TULSA METROPOLITAN AREA PLANNING COMMISSION

For Meeting No. 2474

March 21, 2007

**TULSA METROPOLITAN AREA PLANNING COMMISSION
CASE REPORT**

Access and Circulation
 Vehicular and Pedestrian
EXHIBIT 'C'
 Planned Unit Development Number 738

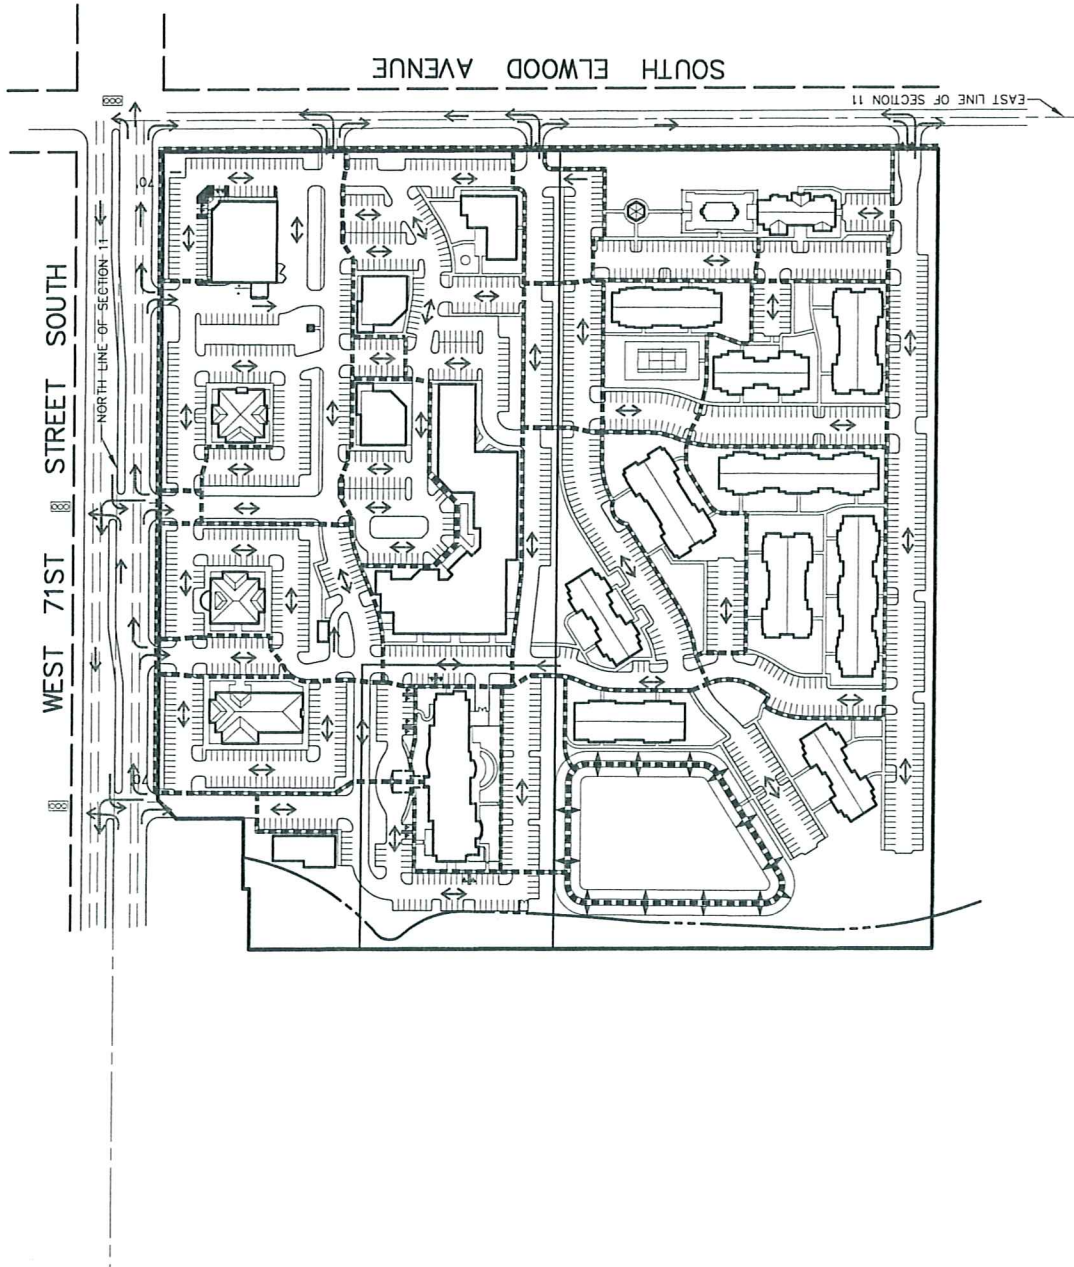
Traffic: Relocate the driveway connection for the apartments to the center access aisle at least 100ft west and eliminate parking within the 100ft approach. The westernmost access on 71st St. and the center access on Elwood are recommended for widening to provide 2 out/1 in bound lanes for increased capacity in addition to those shown widened on Exhibit "A". Provide a Mutual Access Easement from the Hotel Lot to 71st St. or a panhandle ownership. Please delete the symbols shown on Exhibit "C" implying a "Traffic Signal" at two of the 71st
